WILLERBURN ACRES

ADMINISTRATIVE SUBDIVISION PLAN NO. 620230040

PRELIMINARY/FINAL FOREST CONSERVATION PLAN NO. F20230030

No. 620230040

Figure 6 - Tree Variance Exhibit

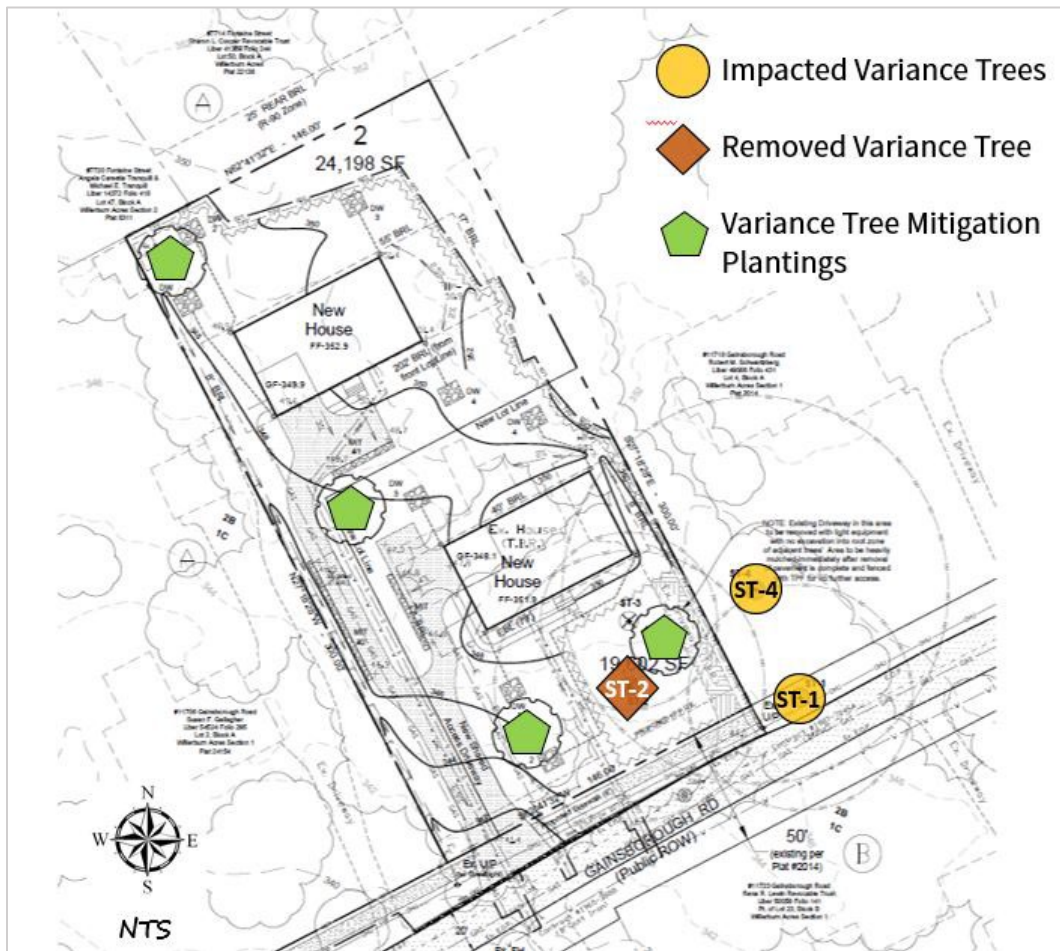
The Applicant submitted a variance request in a letter dated May 16, 2023 (Attachment C). The Applicant proposes to remove one and impact two trees that are 30 inches or greater DBH, that are considered high priority for retention under Section 22A-12(b)(3) of the County Forest Conservation Law (Table 4).

The inability to impact or remove these trees would potentially render portions of the site undevelopable for this project or pose threats to the health, safety and welfare of future homeowners. Therefore, there is a sufficient unwarranted hardship to justify a variance request because the Applicant would otherwise be denied the ability to use the Property for the development of single-family detached homes allowed under the zone, which is a reasonable and significant use of the Property.

FIRE DEPARTMENT APPARATUS ACCESS & WATER SUPPLY PLAN  
**Wilderburn Acres**  
 Lot 3, Block A of Section 1 - 11712 Gainsborough Road  
 Montgomery County, Maryland

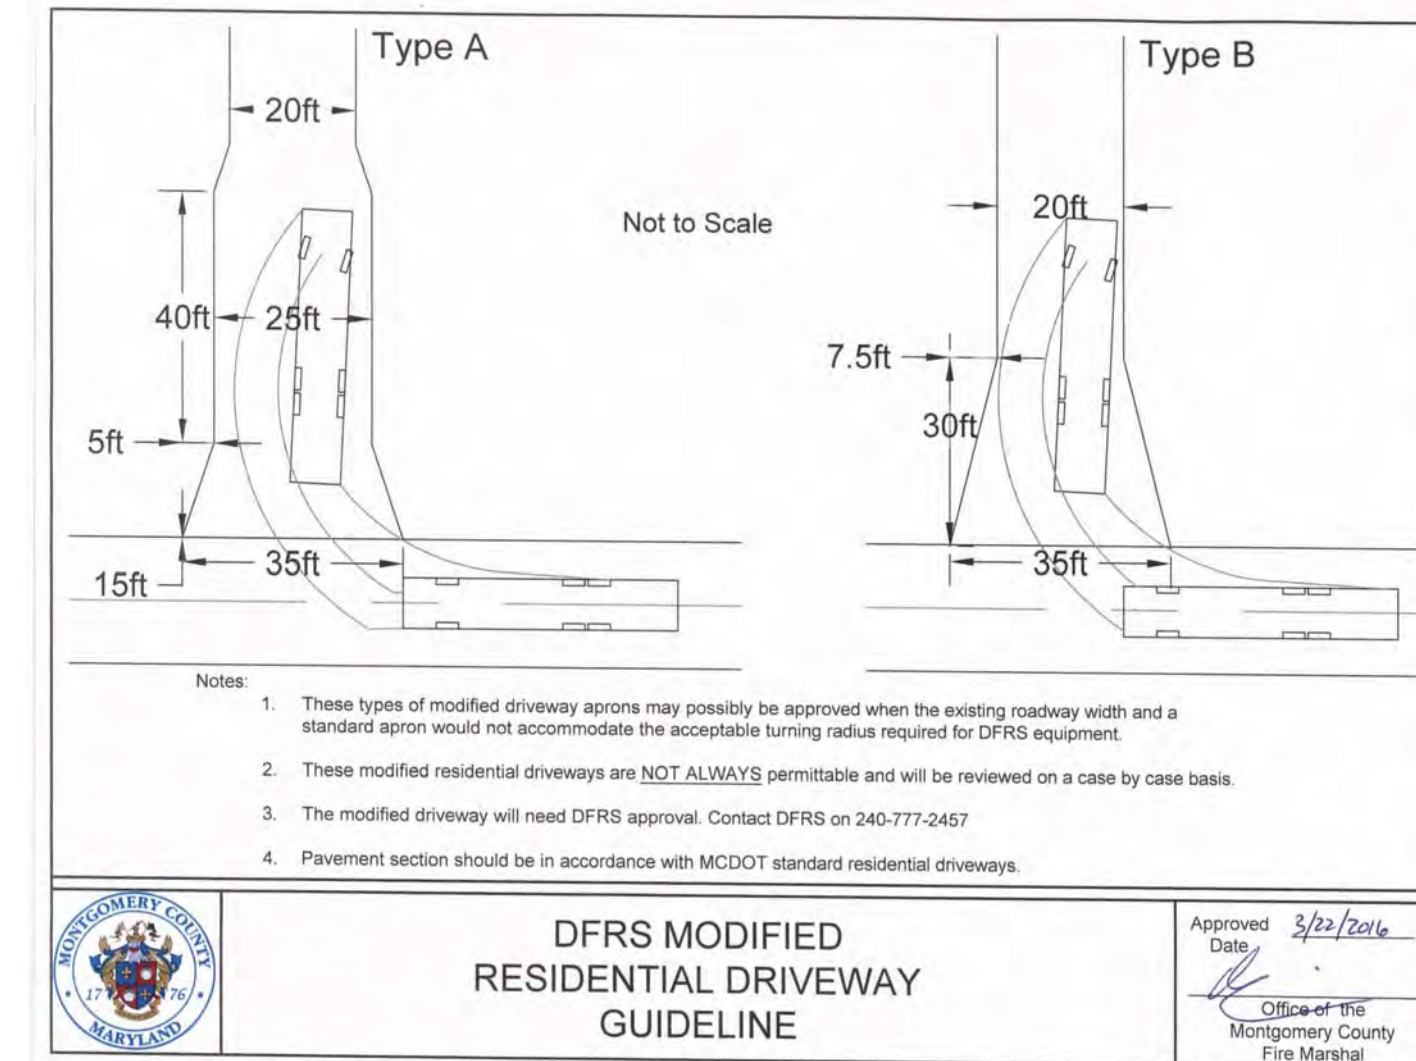
- Portions of Gainsborough Road measure less than 20 feet wide in the area of the site. The road is proposed to be widened as shown on the plan to a minimum of 20 feet of paved width between the hydrant and the proposed driveway.

- The height restriction (see detail this plan) applies to the proposed houses on each lot based upon the building restriction lines (BRL's) shown on this plan (less than 15 feet). If BRL's of 15 feet or more are provided along all sides, the height restriction would not apply.

**FIRE CODE ENFORCEMENT**  
 Fire Department Access Review  
 Review based only upon information contained on this plan. Does not cover unsatisfactory layout resulting from omissions, errors or failure to clearly indicate conditions on this plan. Correction of such unsatisfactory layout to afford required access will be required if found upon inspection after installation.  
 BY: SAC FM: 43 DATE: 5/20/2023

**PRELIMINARY / FINAL FOREST CONSERVATION PLAN**  
**Willerburn Acres**  
Lot 3, Block A of Section 1 - 11712 Gainsborough Road  
Montgomery County, Maryland

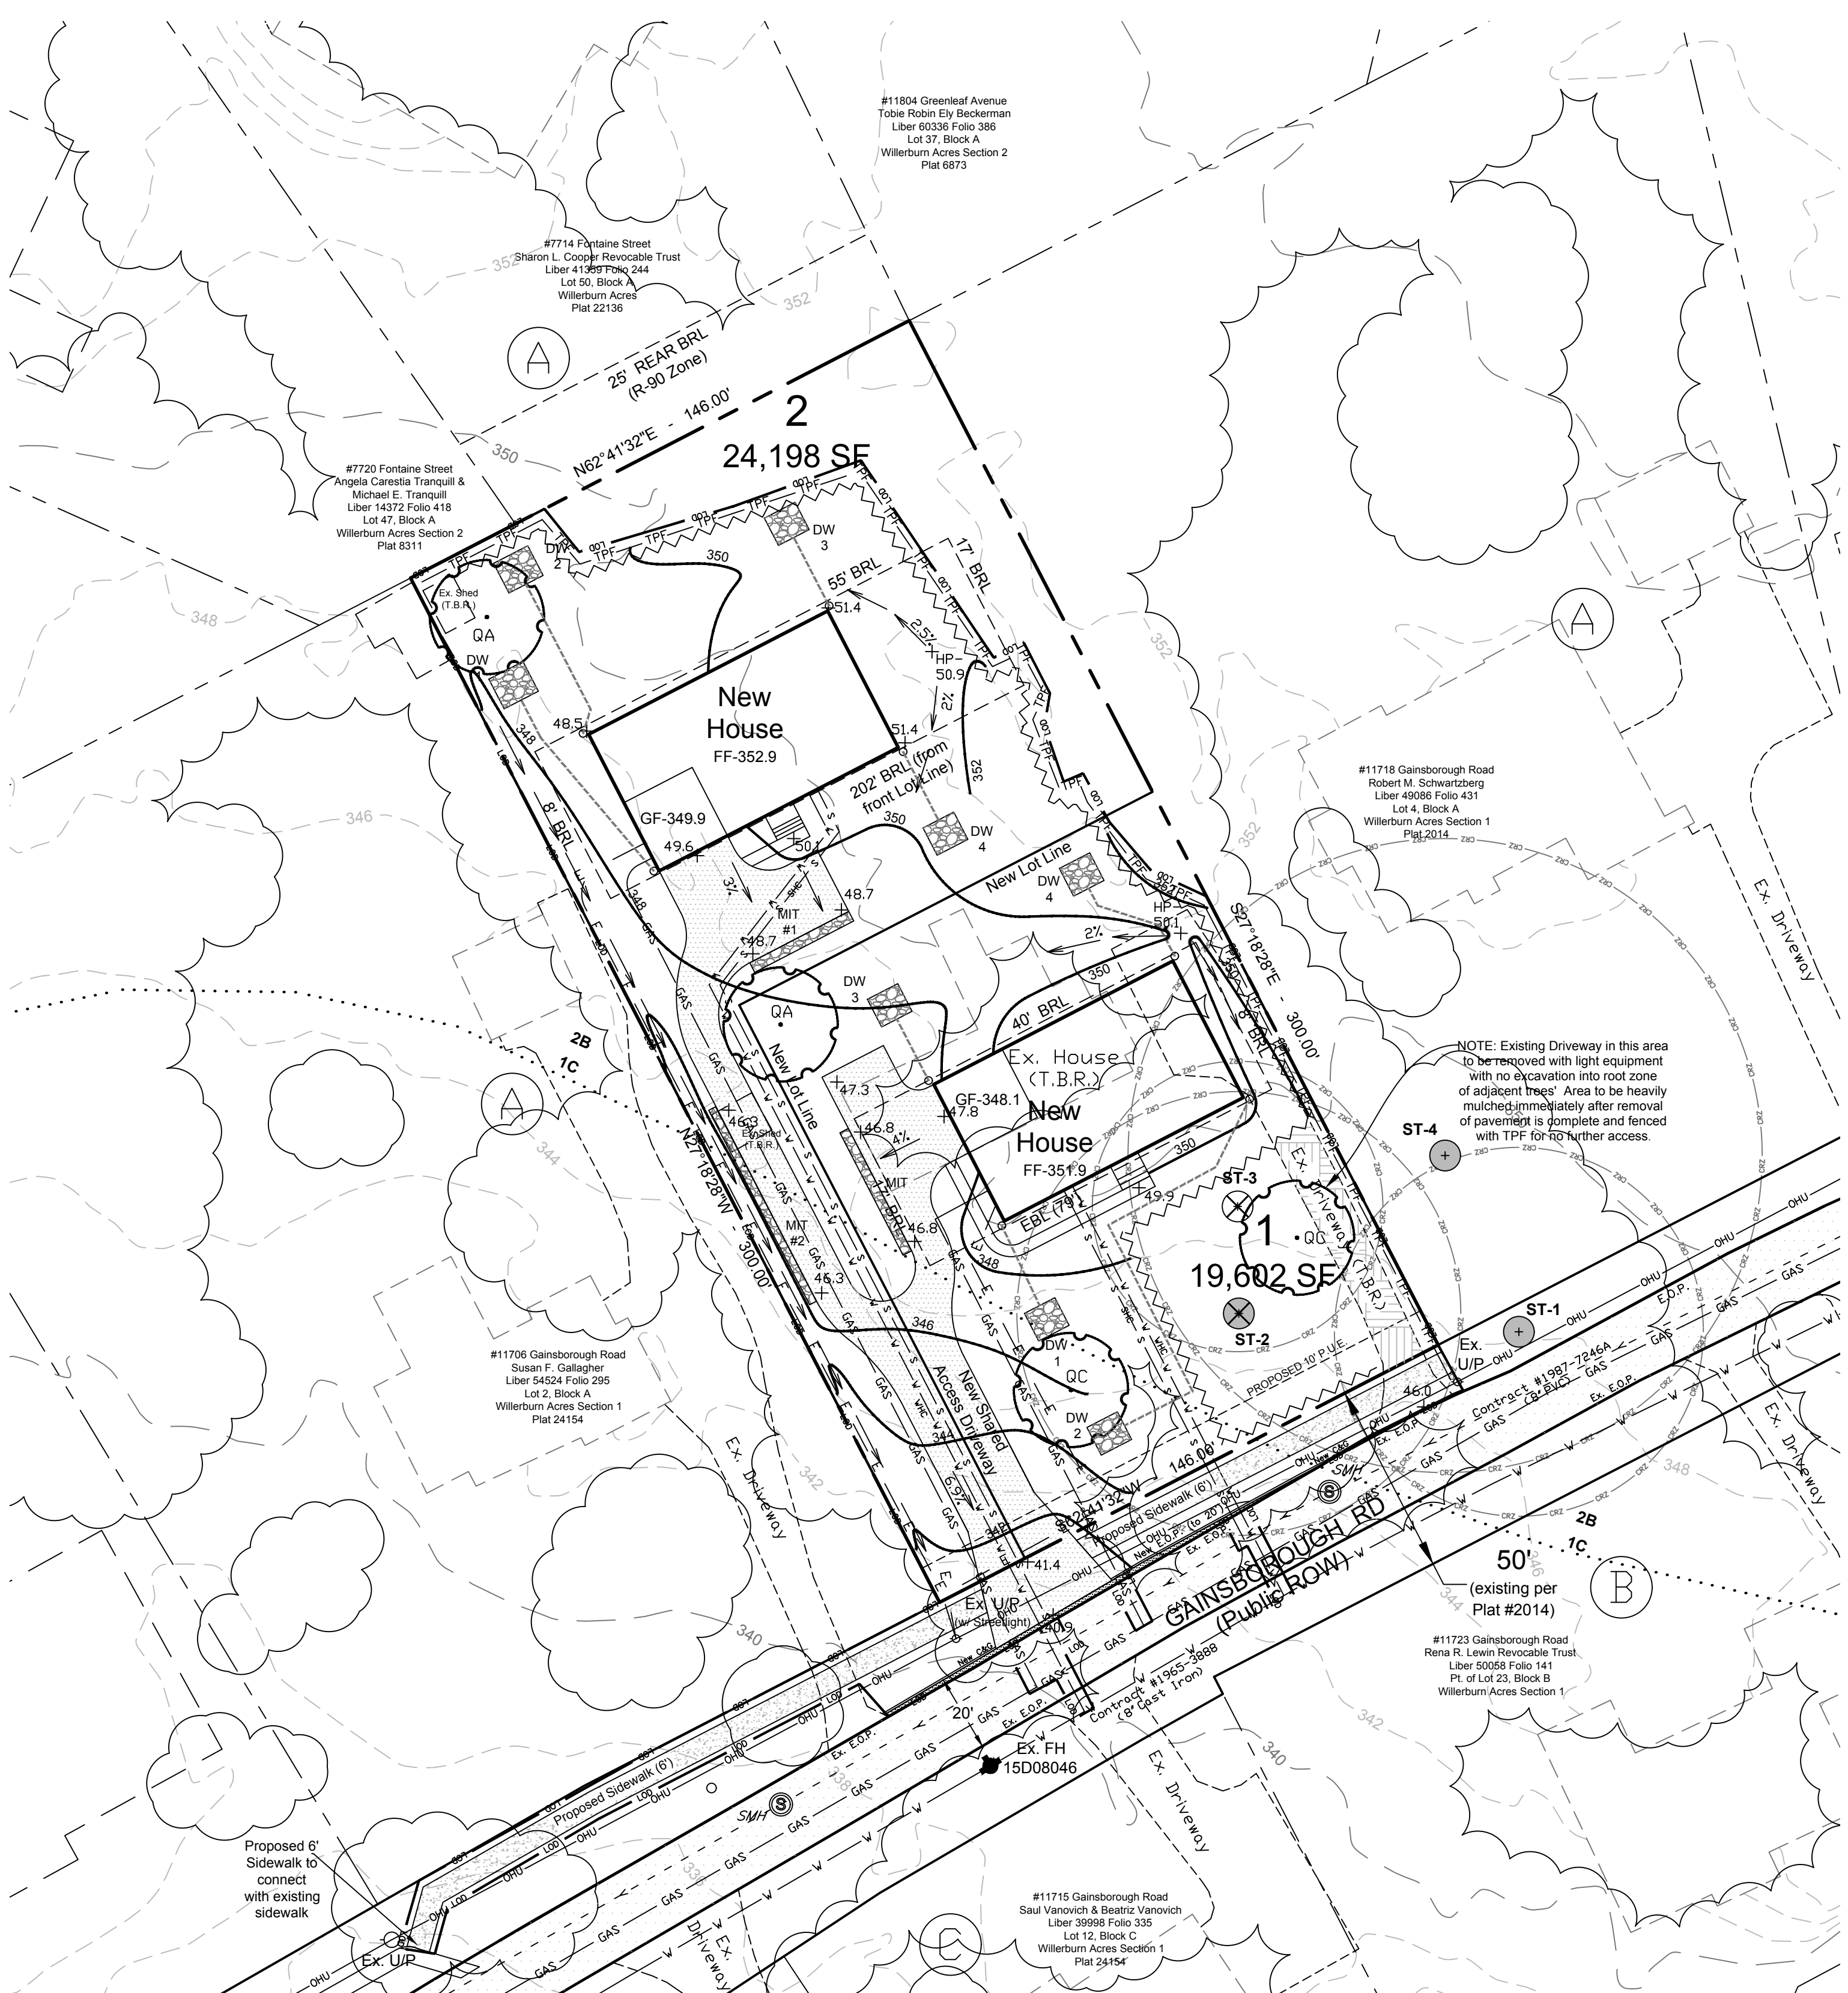
**NOTE:** The locations of ST-2 and ST-3 were reversed on the approved NRI/FSD. The correct locations are shown on this plan.
